# ***i960<sup>®</sup> VH Embedded-PCI Processor***

*Specification Update*

*August 2004*

Order Number: **273174-011**

**Figure 1. DRAM RAS# Configurations**

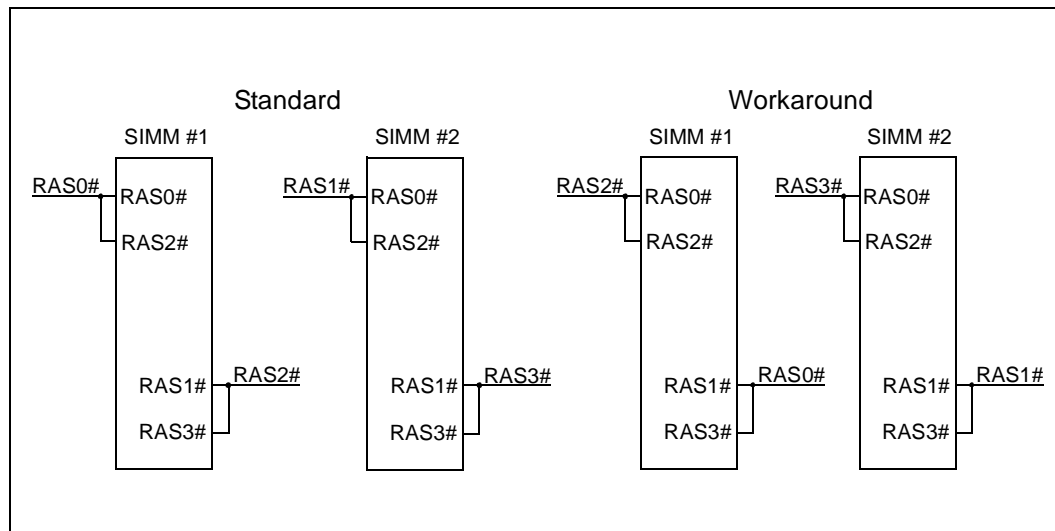
### CASE 2 WORKAROUND - Initializing from 80960VH DRAM instead of FLASH/ROM

In a standard DRAM configuration, RAS0# and RAS1# are routed to the front sides of the SIMMs, and RAS2# and RAS3# are routed to the back sides of the SIMMs. To implement this workaround, swap RAS0# and RAS2# and swap RAS1# and RAS3#. This routes RAS2# and RAS3# to the front sides of their respective SIMMs, and routes RAS0# and RAS1# to the back sides of their respective SIMMs (See [Figure 1](#)). To determine which RAS# is asserted for a particular address and DRAM configuration, see [Table 1](#).

When initializing from 80960VH DRAM, the first instruction fetch of the IBR is hard-coded to address 0xFEFF FF30; as a result, A23:22 = 11<sub>2</sub> and RAS3# is asserted. With the workaround in place, the RAS# lines are swapped and RAS3# is connected to the front side of the second SIMM and the IBR can be read.
